Loudmouth – Occasional No Audio Output

Loudmouth Models covered:

LM-600Analog, LM-700DMR, LM-U450, LM-V150

Change audio PA input capacitors from 1 μ F tantalum capacitors (152A8105) to 0.47 μ F 0805 ceramic capacitors (15119474)

LM-600Analog

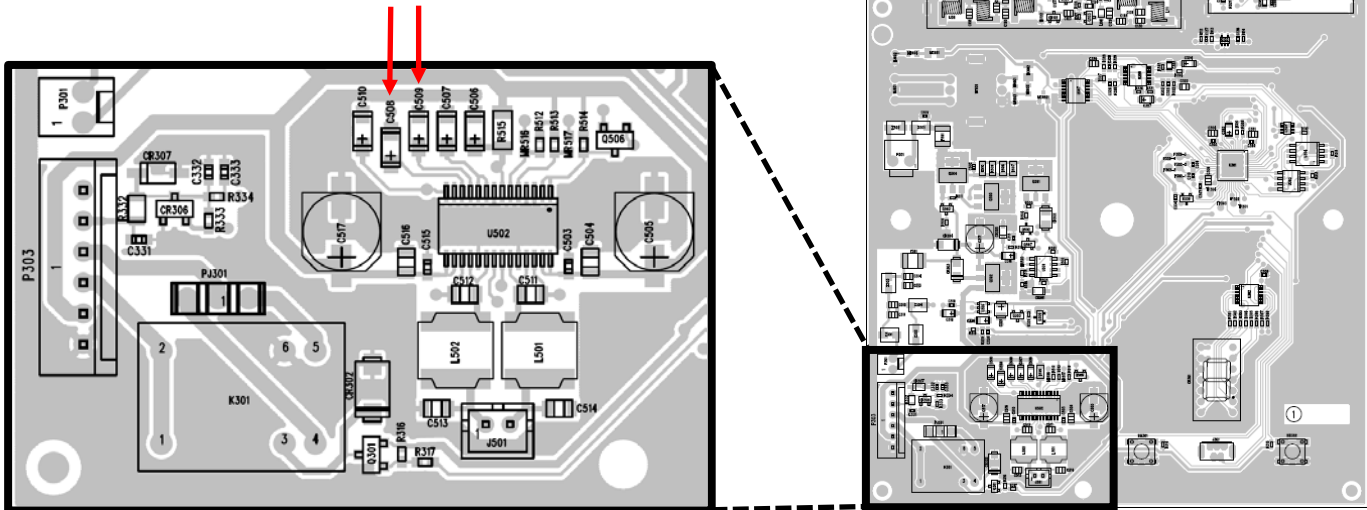
Change **C508** and **C509** to 0.47 μ F 0805 ceramic capacitors (15119474)

LM-700DMR

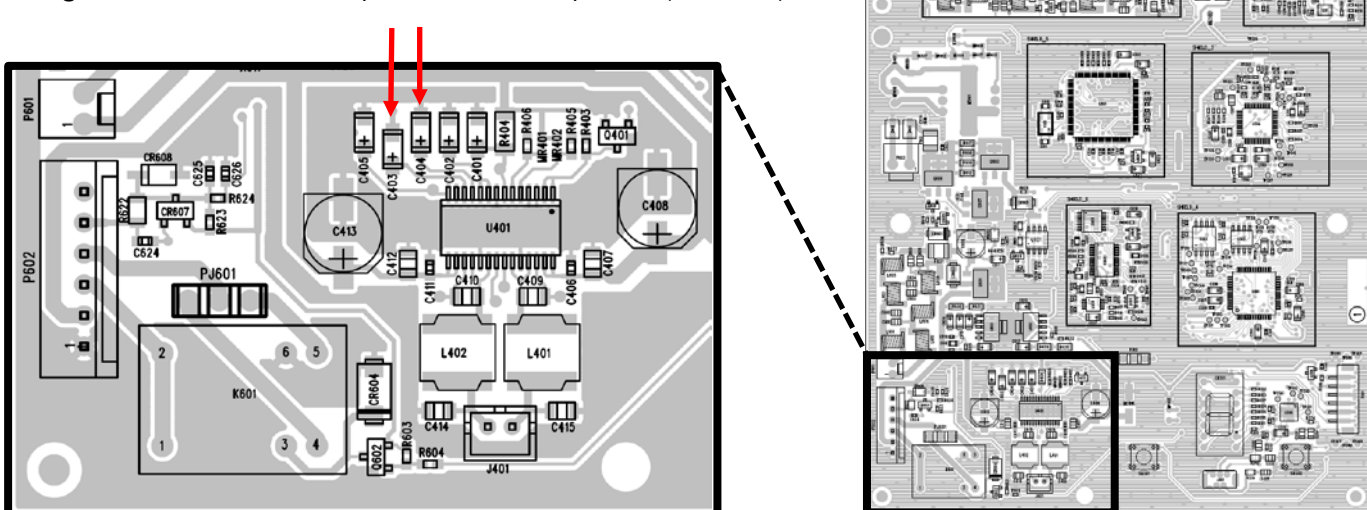
Change **C403** and **C404** to 0.47 μ F 0805 ceramic capacitors (15119474)

LM-U450, LM-V150 Gen 3

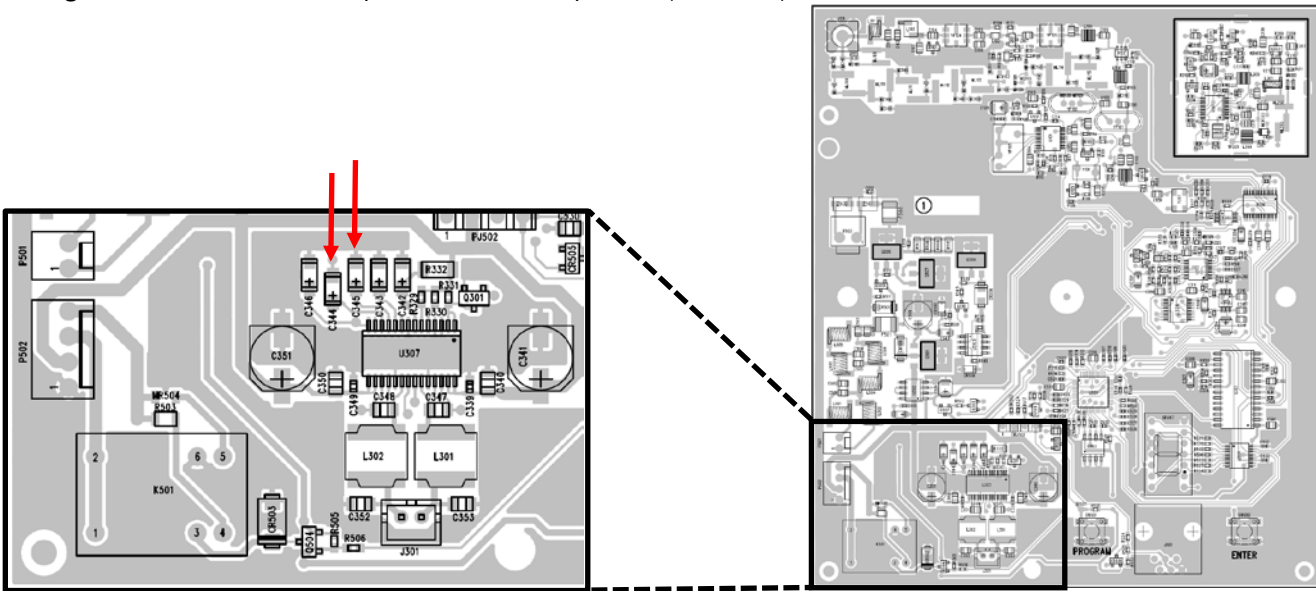
Change **C344** and **C345** to 0.47 μ F 0805 ceramic capacitors (15119474)

Before Change – Tantalum capacitors

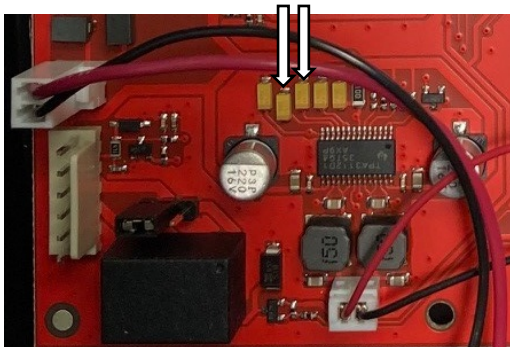
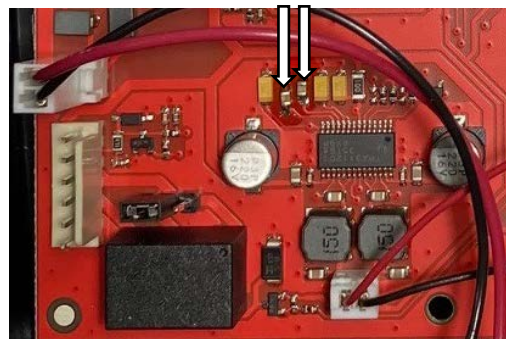
After Change – Ceramic capacitors

LM-U450, LM-V150 Gen 2

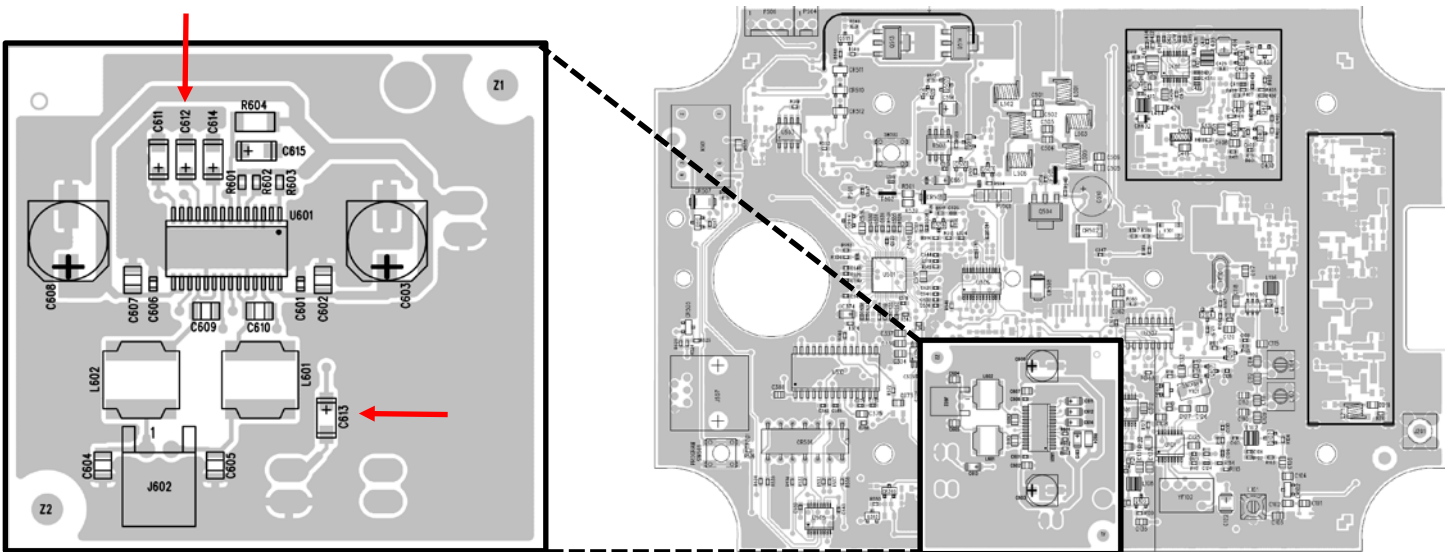
Change **C612** and **C613** to 0.47 μ F 0805 ceramic capacitors (15119474)
